Response to Environment Agency feedback (dated 17/09/2020) on the Port Clarence ESC

This document provides a response to feedback from the Environment Agency dated 17/09/2020 and entitled “Environmental safety case for disposal of low activity low level waste at the Port Clarence landfill sites: feedback from the Environment Agency”.

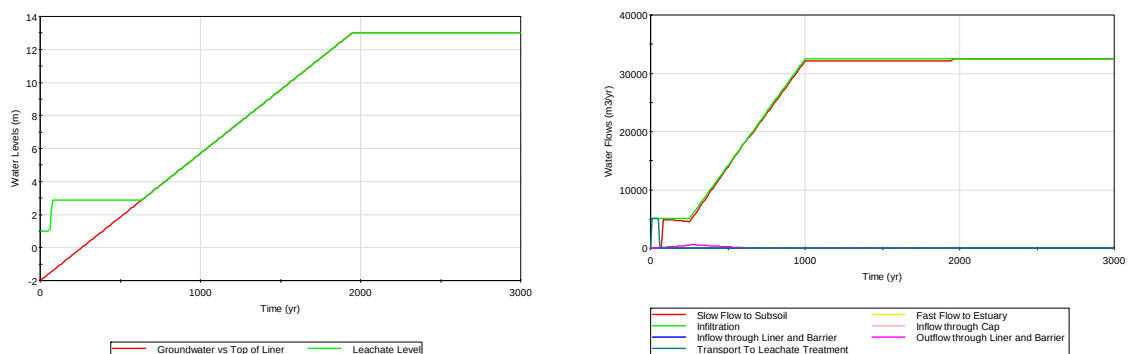
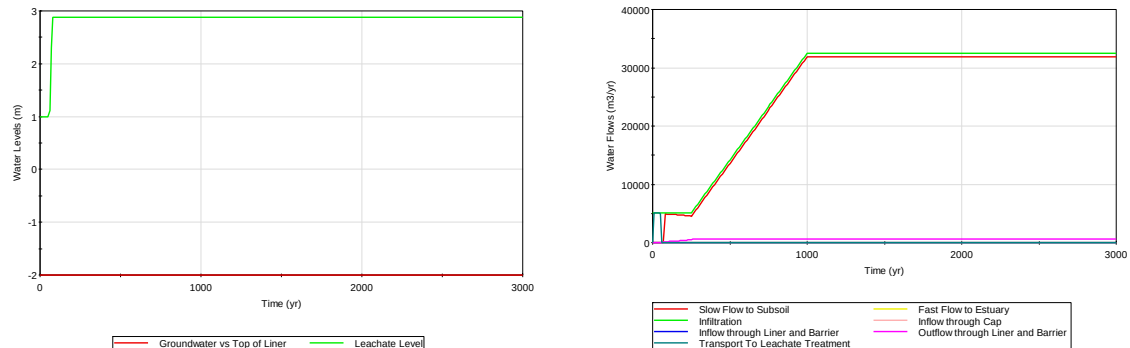
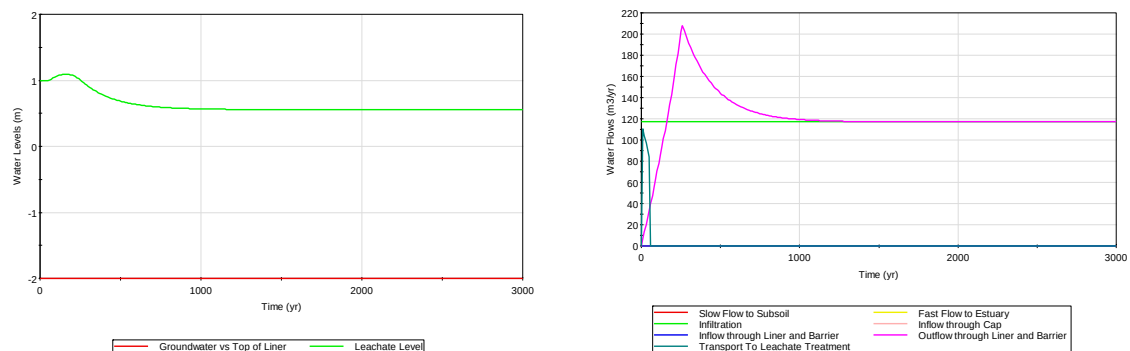
59. Figure 19 and supporting text in paragraph 788 is confusing since the term 'q_out' is not presented and the infiltration through the cap is not visible after about 300 years. The figure appears to show that infiltration through the cap will be approximately an order of magnitude greater than the actual flow of water through the base of the cells. If this situation is correct then we'd expect a rapid increase in leachate levels after the end of leachate management. Augean Plc should address and clarify this point.

The new GoldSim model includes a dynamic water balance model that has been created to consider sea level rise as an additional potential source of water influx into the waste cell. In the revised ESC the text and figure representing the water flow will be replaced with updated versions representing the most recent GoldSim model. The new model no longer uses the term 'q_out'.

Example scenario 1: Linear Climate Change. The seawater level is assumed to rise 15 m over a period of 1950 years. After the period of authorisation, the leachate level rapidly rises to the bund level and leachate breakout occurs. After 250 years, the basal geosynthetic liner is completely deteriorated and the flow through the liner and barrier is completely governed by the clay barrier. The maximum outflow through liner and barrier of 584 m³/y occurs at 270 years because the leachate head continues to decrease due to sea level rise. The groundwater reaches the top of the perimeter bund after 630 years and there is no more leachate pressure on, and hence no leachate flow through, the base of the repository.

Example scenario 2: No Climate Change. Because the groundwater is expected to remain at the current level, an equilibrium sets in after 280 years, the basal geosynthetic liner having fully deteriorated after 250 years, with a flow through the basal clay barrier of 606 m³/y. Excess infiltration water is released to the subsoil as leachate breakout.

Example scenario 3: GCL Cap without Degradation and No Climate Change. With the much lower infiltration rate of 0.73 mm/y, the waste cell does not fill up to the level at which leachate breakout occurs. The flow through the basal barrier and liner increases until the geosynthetic basal liner is completely deteriorated and the flow is governed by the basal clay barrier. At this stage the maximum flow rate of 208 m³/y is reached then the leachate head adjusts itself to a level at which the infiltration rate and the flow rate through the basal clay barrier are both equal to 118 m³/y and equilibrium sets in.
